# ADA Curb Ramp New Construction Inspection Form (Parallel)

NW 307th

23885.56

Eggiman Ct

PARALLEL RAMP (PL)

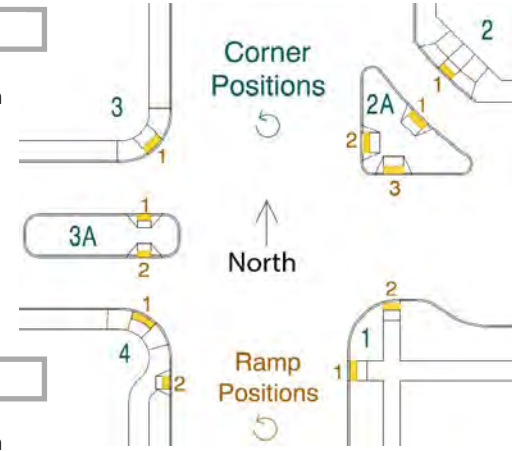
2.7  $\leq 2.0\%$  ☐  $> 2.0\%$  ☒

5.8  $\leq |5.0\%|$  ☐  $> |5.0\%|$  ☒

8.5  $\leq 8.3\%$  ☐  $> 8.3\%$  ☒

2.7  $\leq 2.0\%$  ☐  $> 2.0\%$  ☒

Comments:

Poor craftsmanship, RR2, IITD
